Lake Dallas CTE - Theatre Lighting, Theatre Rigging Punch List

Created: 10-27-2025
Creator: Jeff Mabray (@JMA)
Status: Missing, Not Installed, Not Complete, Incorrect, Unable To Inspect
Dates: 07-18-2025 - 10-27-2025

WJHW representatives made a site visit on 10/10/25. While on site we met with Crossland General Contractors.

#33 - EC still working on circuiting and arch. fixtures.

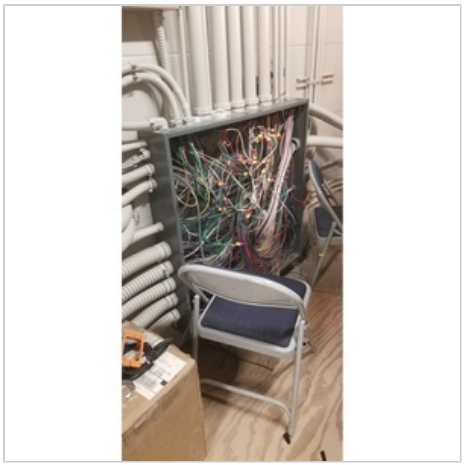
EC still working on circuiting and arch. fixtures.

#9 - PB and DMX Devices Not Installed

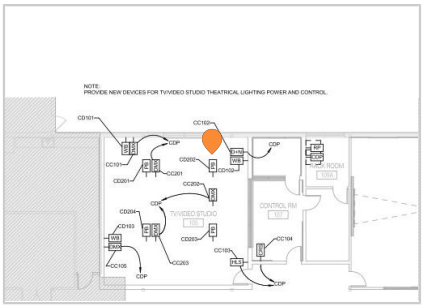
Alex Robertson	no pipe grid has been installed in the studio.	22 Jul 10:47 AM
Chris Purpura	PB & DMX devices not complete & tested. Finish programming and labeling ETC - Complete	ct 06:05 PM
Chris Purpura		10 Oct 06:10 PM
Chris Purpura	Install plates on preset stations and finish programming. ETC - Complete	10 Oct 06:10 PM

#10 - RP and CDP Devices Not Installed

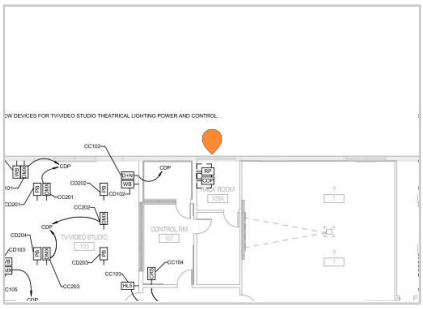
Alex Robertson	The RP and CDP devices were not installed or conduit ran into rack room. No electrical circuits have been identified to power either device.	22 Jul 10:49 AM
Chris Purpura	Finish labeling CDP. Overall system not working, finish programming. ETC - Complete	10 Oct 06:09 PM

#22 - Provide labelling for the CDP. Finish labeling of the cables to match the as-builts.

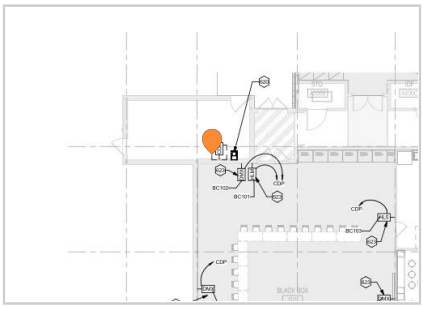
Chris Purpura	Provide labelling for the CDP. Finish labeling of the cables to match the as-builts.	10 Oct 06:14 PM

ETC - Complete

#23 - Provide cover over existing preset station.

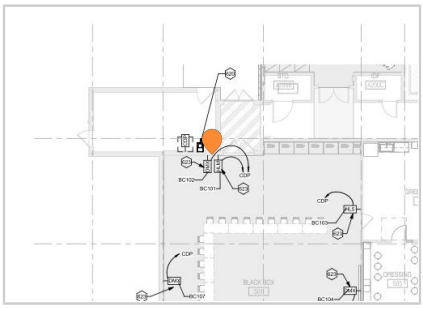
Chris Purpura — Provide cover over existing preset station. ETC - Out of Scope — 10 Oct 06:15 PM

#24 - Install plates on all HL presets in auditorium (typical). Finish programming on all preset stations.

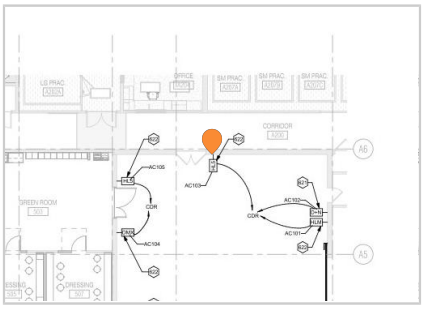
Chris Purpura		10 Oct 06:17 PM
Chris Purpura	Install plates on all HL presets in auditorium (typical). Finish programming on all preset stations. ETC - Complete	10 Oct 06:18 PM

#25 - Install plates on all HL presets in auditorium (typical). Finish programming on all preset stations.

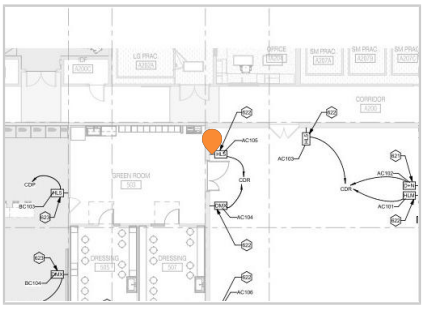
Chris Purpura	Install plates on all HL presets in auditorium (typical). Finish programming on all preset stations. ETC - Complete	10 Oct 06:19 PM

#26 - Finish testing on relocated NET device.

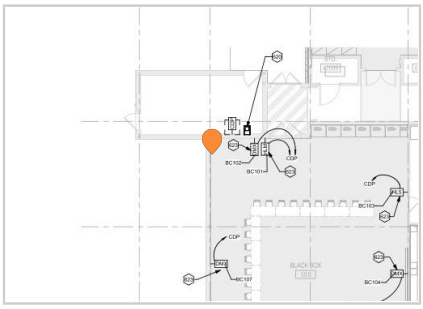
Chris Purpura	Finish testing on relocated NET device.	ETC - Complete	10 Oct 06:23 PM

#27 - Existing preset stations not preset. Key switches in place that are not installed part of the architectural lighting system. Finish installation & programming.

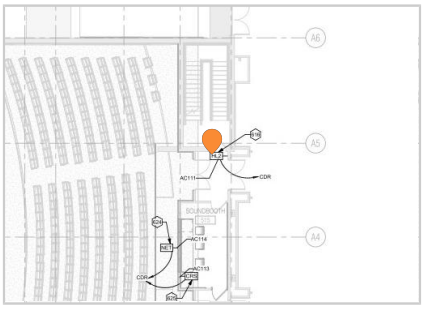
Existing preset stations not preset. Key switches in place that are not installed part of the architectural lighting system. Finish installation & programming.

ETC - These are not ETC controls.

#28 - Existing preset stations not preset. Key switches in place that are not installed part of the architectural lighting system. Finish installation & programming.

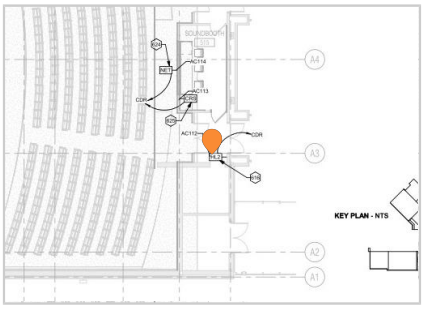
Chris Purpura	Existing preset stations not preset. Key switches in place that are not installed part of the architectural lighting system. Finish installation & programming. ETC - These are not ETC controls.	10 Oct 06:30 PM

#29 - Console fader wing is damaged. Replace & confirm prog ramming.

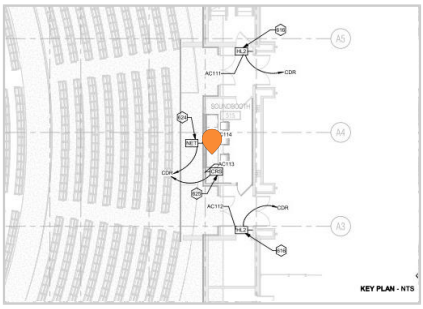
Chris Purpura	Console fader wing is damaged. Replace & confirm programming.	10 Oct 06:30 PM

ETC - Infinity to resolve

#30 - Remove zip ties. Provide tie line on Electrics.

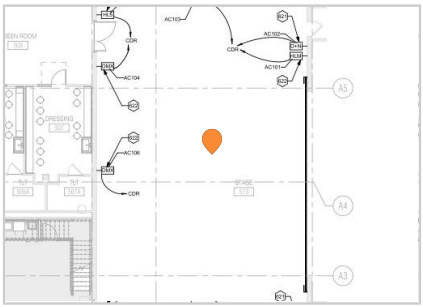
Chris Purpura	Remove zip ties. Provide tie line on Electrics.		10 Oct 06:32 PM
Chris Purpura	Provide adaptors for worklights.		10 Oct 06:33 PM
Chris Purpura	Provide circuit labels on both sides of the connector strip.	ETC - Complete	10 Oct 07:10 PM
Chris Purpura	Provide and set-up portable HLM.	ETC - Complete	10 Oct 07:18 PM

#31 - Set-up and install ETCpad for use.

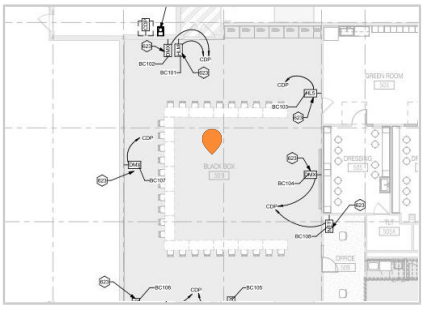
Chris Purpura	Set-up and install ETCpad for use.	ETC - Complete	10 Oct 07:16 PM
Chris Purpura	Finish set-up of HLM.		10 Oct 07:18 PM

#32 - Finish labeling of CDR rack and match as-builts.

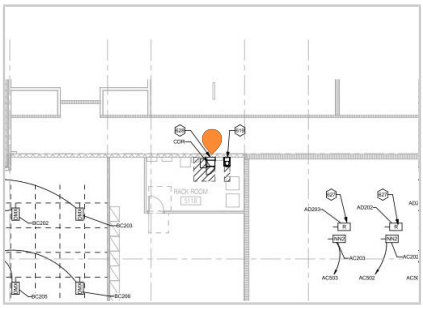
Chris Purpura	Finish labeling of CDR rack and match as-builts.	ETC - Complete	10 Oct 07:20 PM

#34 - Finish installing plates & preset programming.

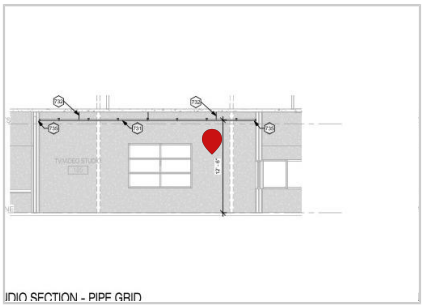
Chris Purpura — Finish installing plates & preset programming. ETC - Complete — 11 Oct 10:10 AM

#11 - MCC

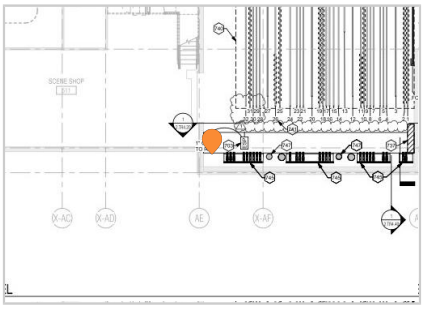
Paul Brunner		10 Oct 09:48 AM
Paul Brunner	Label for motor control cabinet not filled out and not mounted to cabinet.	10 Oct 09:49 AM
Paul Brunner		10 Oct 09:51 AM

#12 - Grid Iron Level

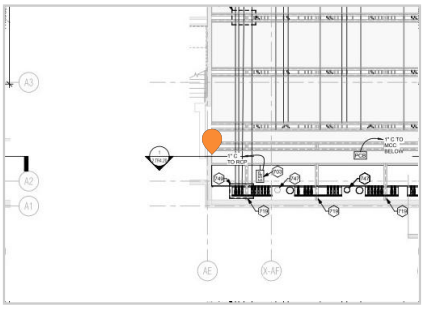
Paul Brunner		10 Oct 09:53 AM
Paul Brunner	Switch at top of ladder at Gridiron level, cover missing.	10 Oct 09:54 AM

#14 - Grid Iron level - Motors

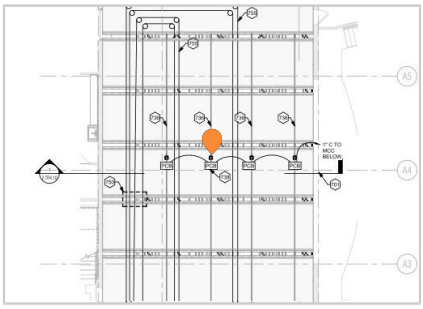
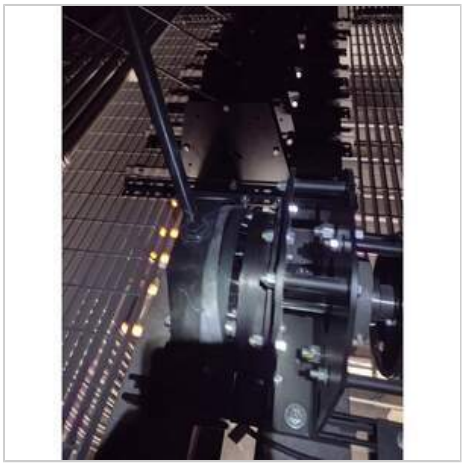
Paul Brunner — Lineshaft Hoists: Wire for secondary brake laying on grid. Dress wire to strut backbone per hoist to protect wire. — 10 Oct 09:57 AM

Paul Brunner — #4 Electric Hoist: protective rubber boot not covering brake. Adjust rubber boot to protect brake assembly. — 10 Oct 09:58 AM

#15 - Grid iron Level

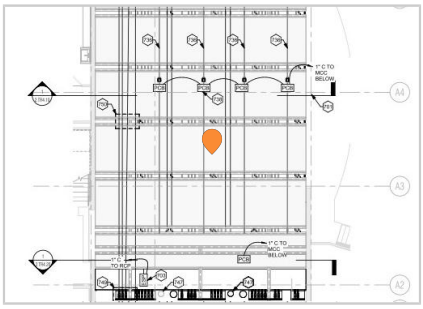
Remove all debris from Gridiron and Rigging Gallery levels.

New specified drapery not on site and not installed.

#19 - Theatrical Battens

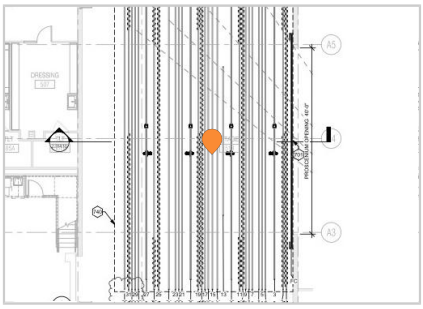
Paul Brunner		10 Oct 10:30 AM
Paul Brunner	Batten splice bolts missing or not properly installed.	10 Oct 10:47 AM
Paul Brunner	Batten end caps not labeled with lineset number or lineset capacity. Centerline marking missing on all battens.	10 Oct 10:48 AM

#18 - Fire Curtain

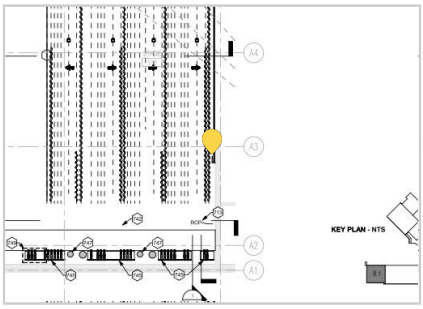
Paul Brunner — Guide wire for Fire Curtain not adequately mounted to stage floor. Floor piece lifting up. — 10 Oct 10:25 AM

#5 - Electrical outlet installed at wrong height

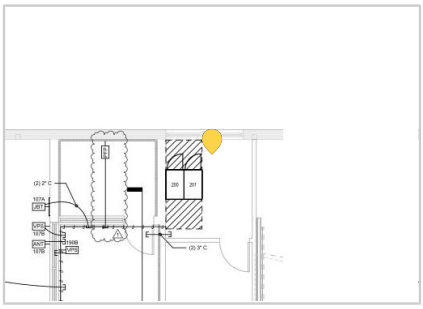
Alex Robertson	Electrical outlet installed at wrong height	22 Jul 10:23 AM
Alex Robertson	L5-20 receptacle should be mounted above the AV rack for this room. Same for other L5-20 receptacle on wall with door.	22 Jul 10:26 AM

#7 - JBE back box not as specified

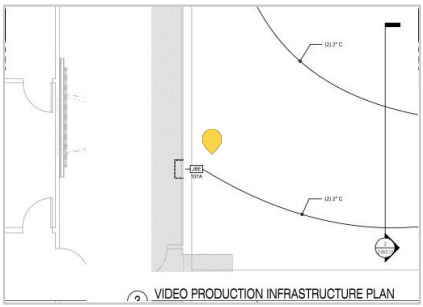
Alex Robertson	Contractor installed incorrect back box. The faceplate will not fit installed back box	22 Jul 10:40 AM
Alex Robertson	To get systems ready for the first of school, the contractor is going to trim faceplate and move receptacles around. They will replace with properly sized faceplate once it's available.	22 Jul 10:41 AM
